**PRODUCT CAMPAIGN BULLETIN**

**APPLICABILITY:** 2026MY Solterra **NUMBER:** WRG-26R

**SUBJECT:** Battery ECU Reprogramming **DATE:** 06/23/26

**REVISED:** 06/29/26

## REPROGRAMMING FILE INFORMATION:

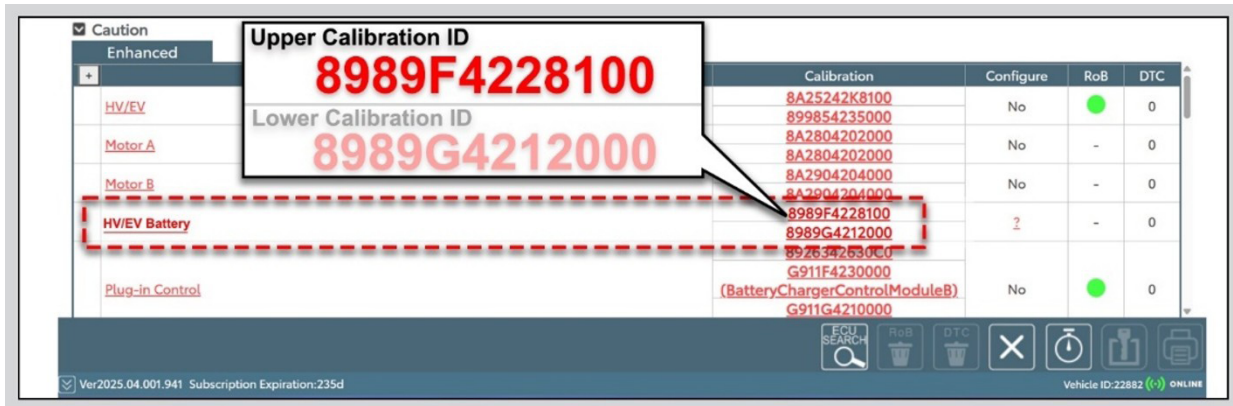
File Description	System	Calibration ID	
		Current	NEW
8989F4228300.cuw	HV/EV Battery	8989F422 <b>8100</b>	8989F422 <b>8300</b>

**NOTE: ONLY** the upper HV/EV battery system Calibration ID is updated after performing the reprogramming procedure.

8989F422 “**8100**”: [Reprogramming required.](#)

8989F422 “**8200**” / “**8300**”: [Reprogramming NOT required](#) (updated software already applied).

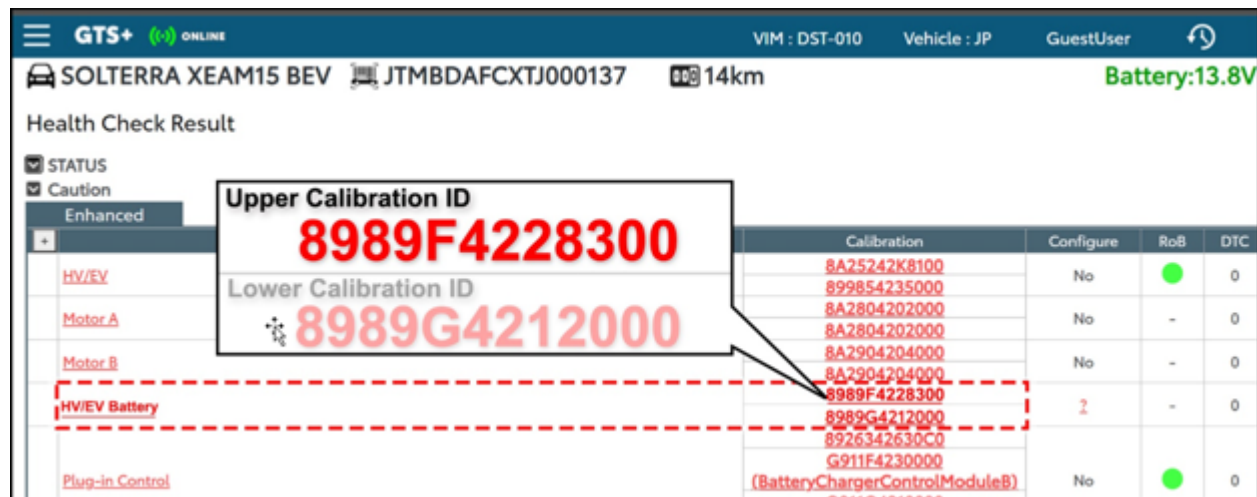
**STEP 6:** After the reprogramming procedure is completed, confirm the Calibration ID has been updated by comparing the “Before Update” and “After Update” values.

**STEP 7:** Perform a Health Check and clear any DTCs acquired during reprogramming. View the Health Check result screen and confirm the upper Calibration ID of the “HV/EV Battery System” has been updated to “8989F4228300”.
